Access Compliance Report Public Rights-of-Way (Curb Ramps)

Main Street: S_GILBERT_ST Cross Street: HARRIET_LN Location: N

ADA ID: RPRK210923125228 Ramp Type: Type 1 - Perpendicular Diagonal Initial Pass/Fail: Fail Overall Compliance: No Severity Score: 15

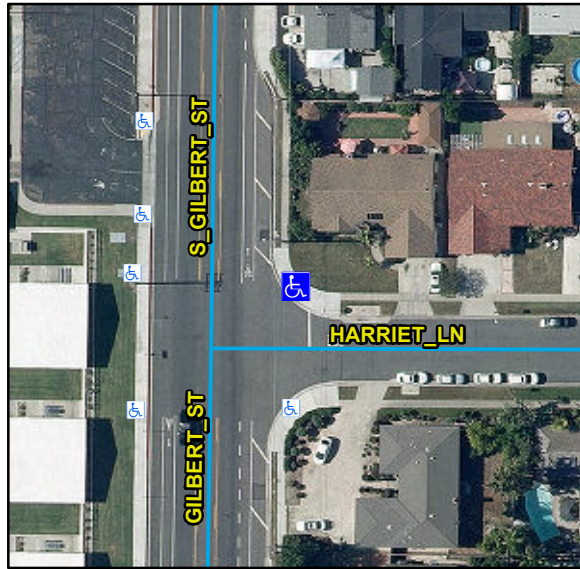
Compliance	Description	Data	Compliance	Description	Data
N/A	Ramp Length (in)	97	N/A	Flare Type LT	
Yes	Ramp Width (in)	48			N/A
No	Ramp Run Slope (%)	9.4	N/A	Flare Slope LT (%)	N/A
Yes	Ramp Cross Slope (%)	0	N/A	Flare Traversable LT	N/A
N/A	Landing Present	N/A	N/A	Flare Type RT	
N/A	Landing Length (in)	N/A			N/A
N/A	Landing Width (in)	N/A	N/A	Flare Slope RT (%)	N/A
N/A	Landing Run Slope (%)	N/A	N/A	Flare Traversable RT	N/A
N/A	Landing Cross Slope (%)	N/A	N/A	DWS Provided	N/A
N/A	Landing Movement Obstructed?	N/A	N/A	DWS Contrast	N/A
	Landing Movement Type	N/A	N/A	DWS Length (in)	N/A
N/A	Landing Shared	N/A	N/A	DWS Full Width	N/A
N/A	Clear Space	Yes	N/A	DWS Offset Left (in)	N/A
N/A	Clear Space To Crosswalk (in)	N/A	N/A	DWS Offset Right (in)	N/A
N/A	Marked Crosswalk 1	No	N/A	Marked Crosswalk 2	No
	Crossing 1 Direction	W		Crossing 2 Direction	S
	Marked Crosswalk 1 Width (in)	N/A		Marked Crosswalk 2 Width (in)	N/A

N/A	Ramp Inside Crosswalk 1	N/A	Yes	Ramp Inside Crosswalk 2	N/A
	Crossing 1 Slope (%)	3.3		Crossing 2 Slope (%)	3.8
	Crossing 1 Cross Slope (%)	1.3		Crossing 2 Cross Slope (%)	1.8
N/A	Gutter Ponding	N/A	No	Curb Slope	5.5
Yes	Gutter Lip Height (in)	0		Road Run Slope (%)	1.2
N/A	Gutter Run Slope (%)	N/A		Road Cross Slope (%)	3.34
N/A	Gutter Cross Slope (%)	N/A			
Yes	Overall Surface Condition: Acceptable		Yes	Perp Joint Present	Yes
	Cross Gutter Present?	No		Spandrel Present?	No
	Replace Cross Gutter?	N/A		Replace Spandrel?	N/A

Remove & Replace Curb Ramp With Two New Directional Ramps or Equivalent.

R304.2.2, STD 1115
